ERIE COUNTY WATER AUTHORITY
AUTHORIZATION FORM
For Approval/Execution of Documents
(check which apply)

Subject: Large Service Contract
ECWA Project No. 201900005
Change Order #1

CHANGE ORDER NO. 1

Work Change Directive No. 1

Picture 1
North Venturi

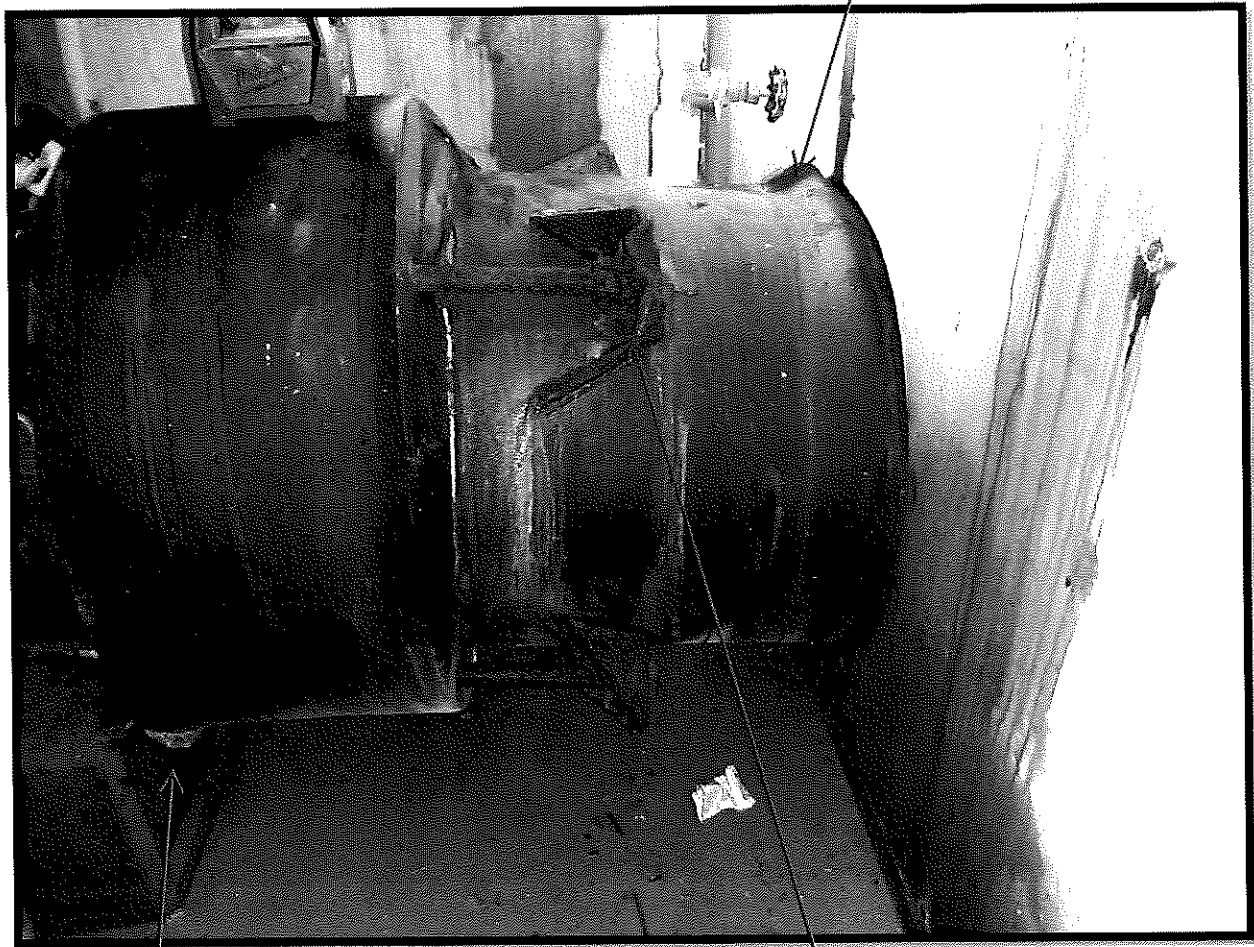
On December 16, 2019 a Pump Mechanic was investigating a high-water alarm at the northern venturi chamber at Ball Pump Station. While he was in the chamber, he noticed that the piping in the chamber is out of alignment. The venturi is currently lifted off its concrete support and the piping at the eastern end of the chamber is bearing on the chamber wall. For the venturi to be lifted off its concrete support, the discharge header outside of the chamber had to move downward. Figure 1 shows the piping layout in the vicinity of the venturi chamber. The current condition of the northern venturi is shown in Picture 1. The central venturi is also displaced, but to a lesser extent. The southern venturi did not show signs of displacement.

Venturi lifted off of
concrete support.

Restraint is
deformed.

Sketch 1 Northern Bypass Piping

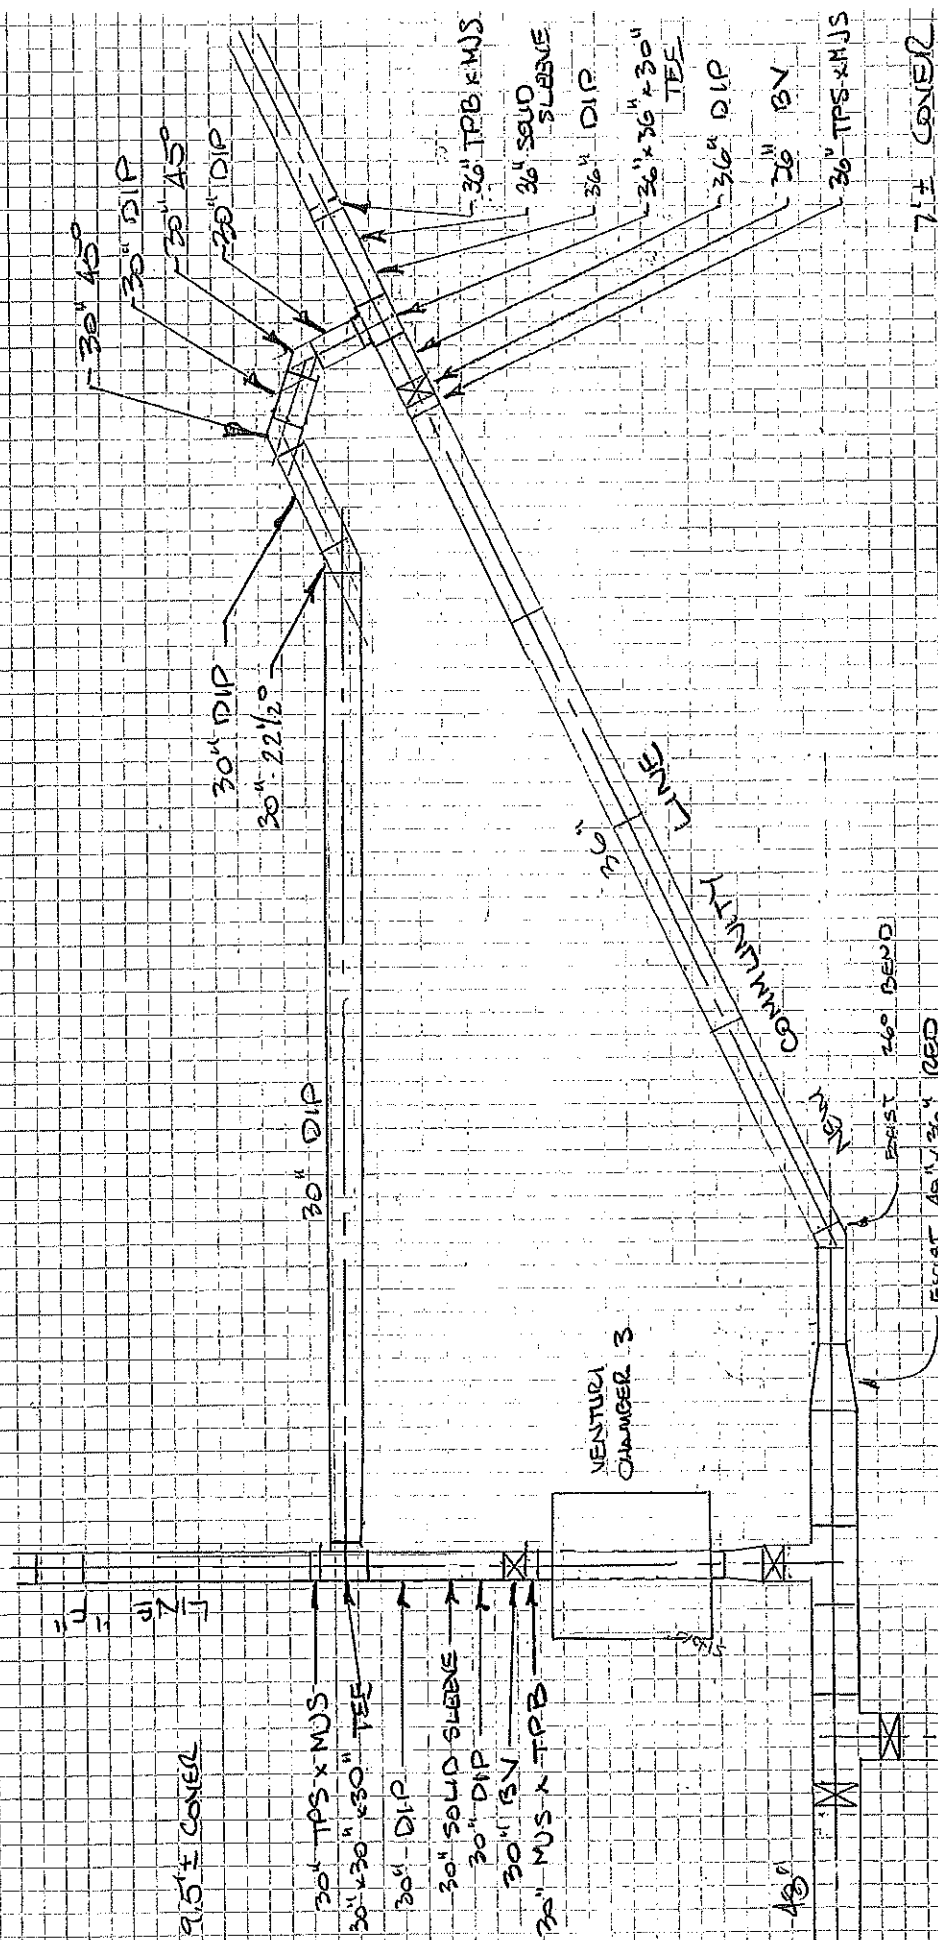
- i. At a point of connection on the west side of the northern venturi chamber, Line "F", install adapters, 30-inch DIP, valve, tee and fittings, to reach grade and alignment;

- ii. Northerly with 30-inch DIP, valves, bends, reducer and fittings to reach grade and alignment;
 - iii. To a point of connection on the 36-inch PCCP "New Community Line" with adapters, 36-inch DIP, valves, tee and fittings to reach grade and alignment.
